DESIGN CONFIDENCE

Boston Global

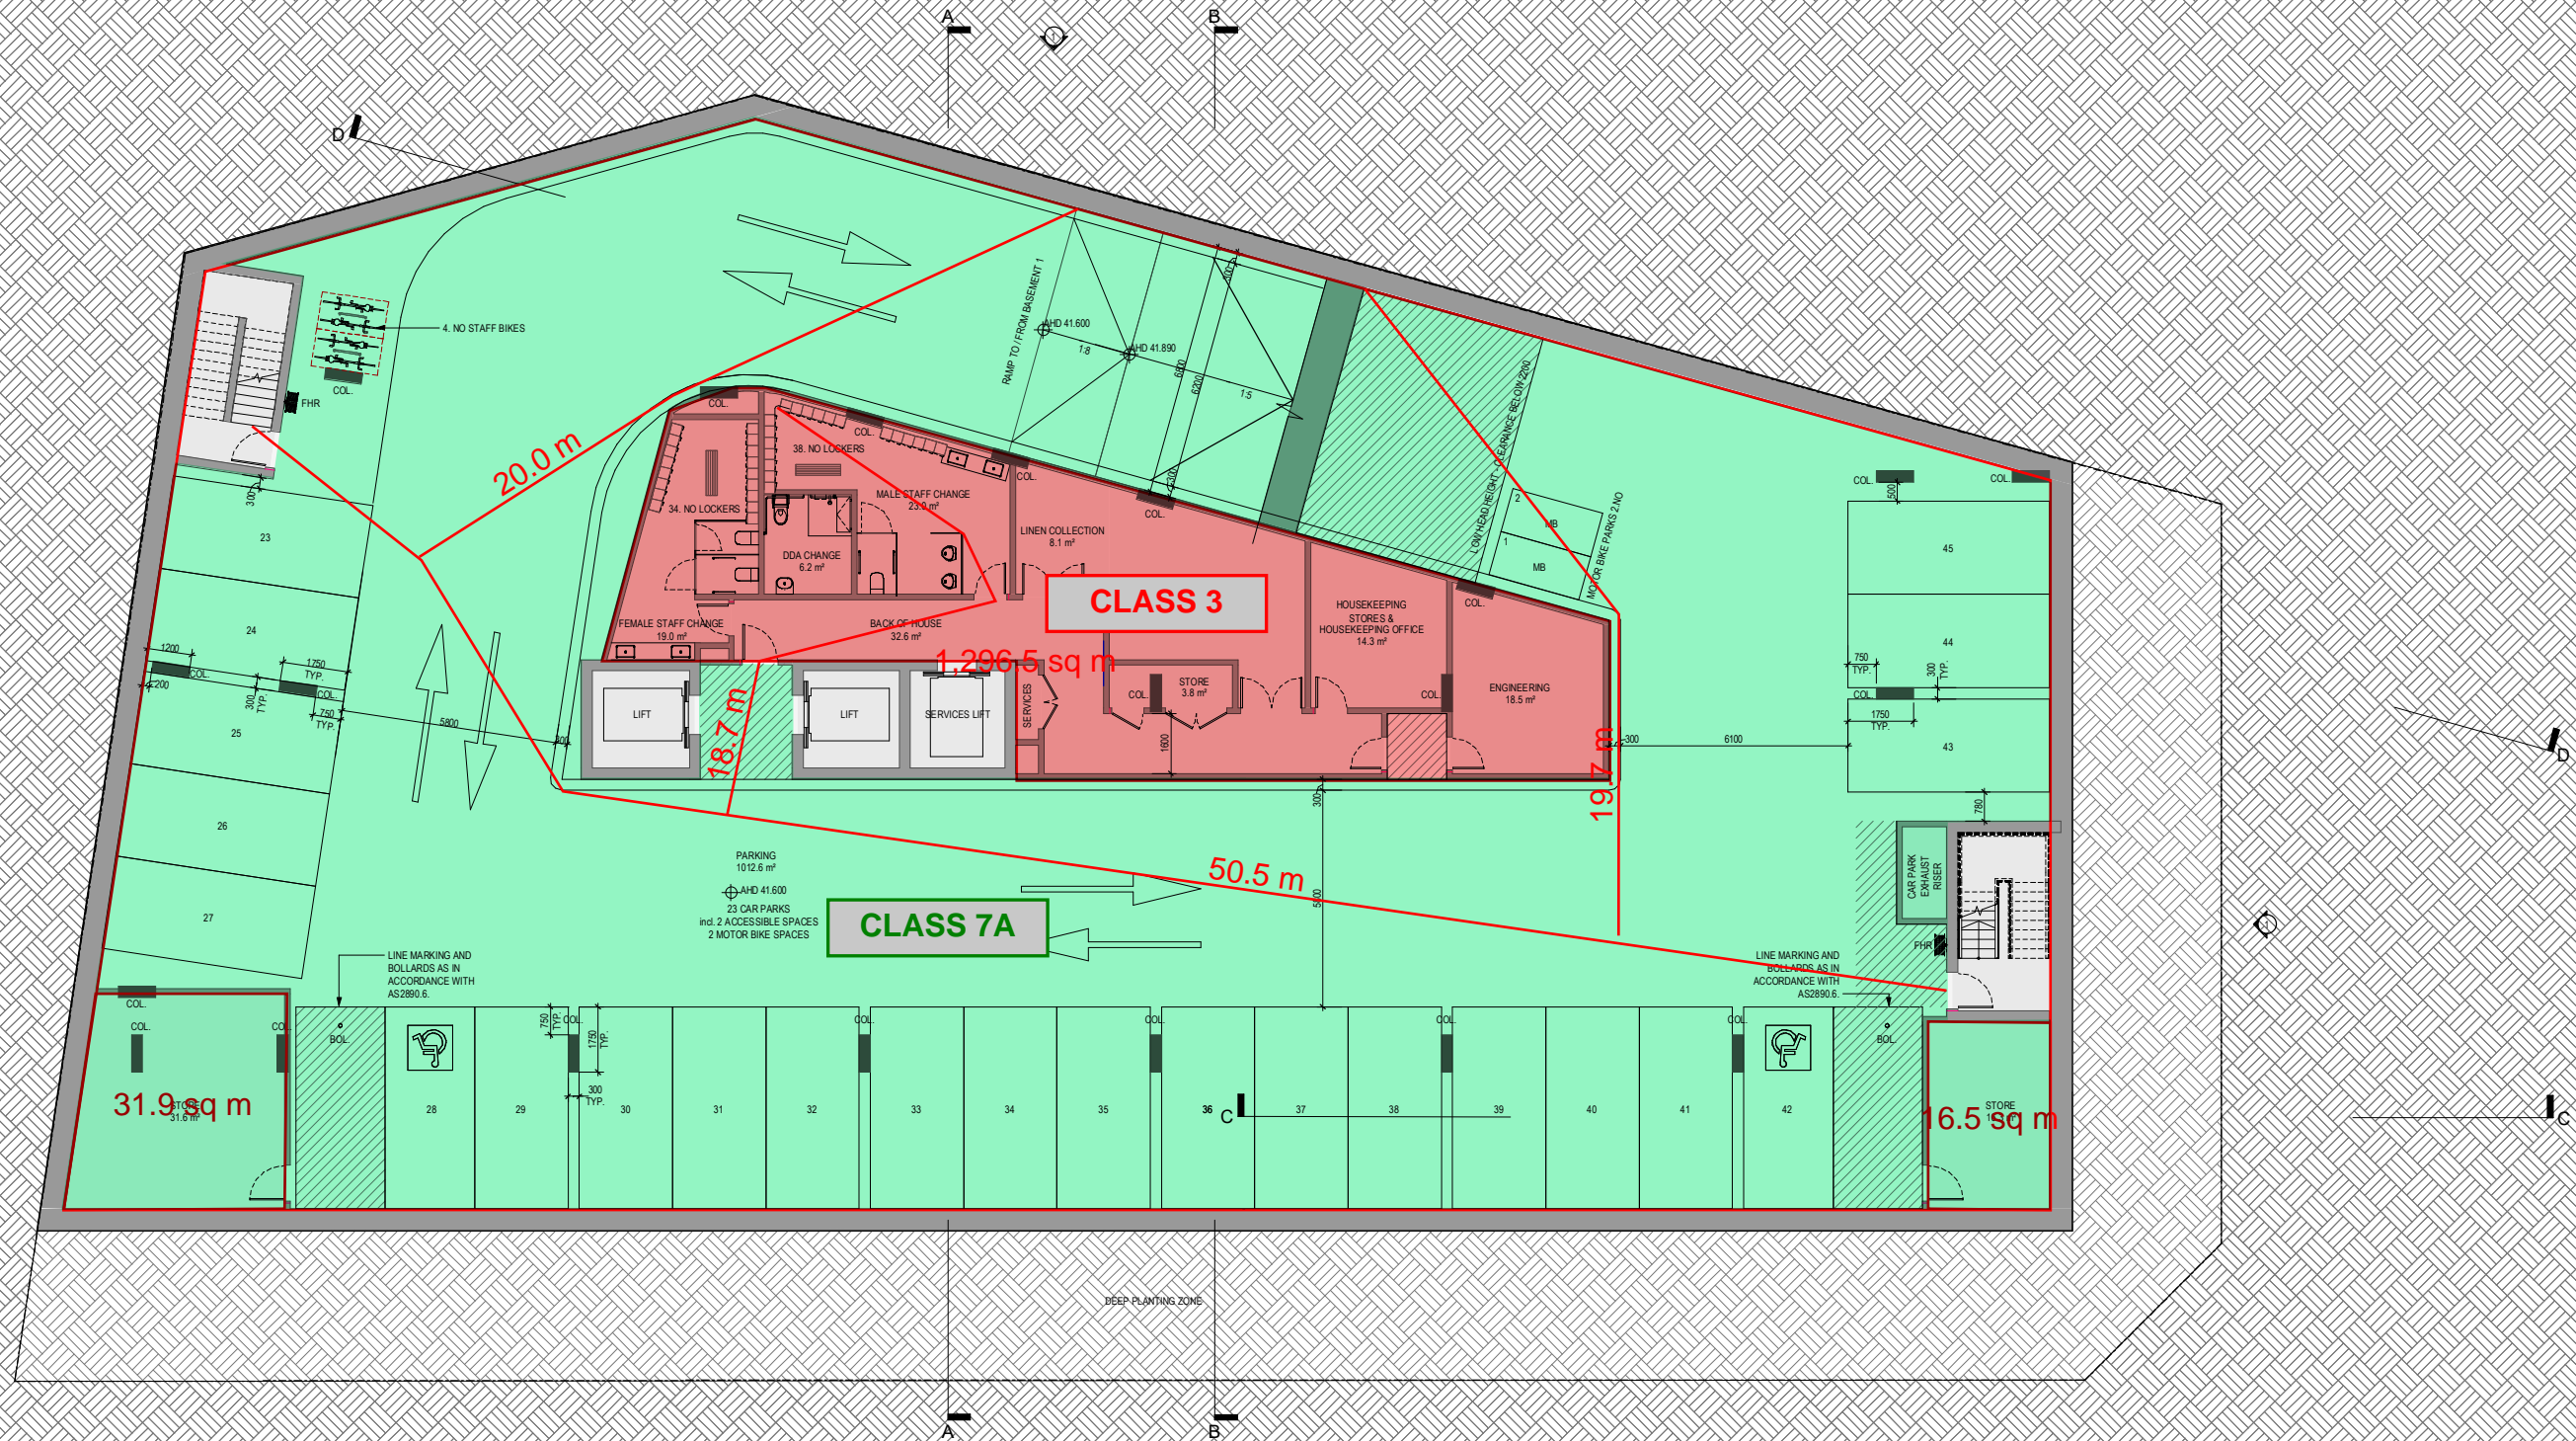
APPENDIX 4 – PLAN MARKUPS
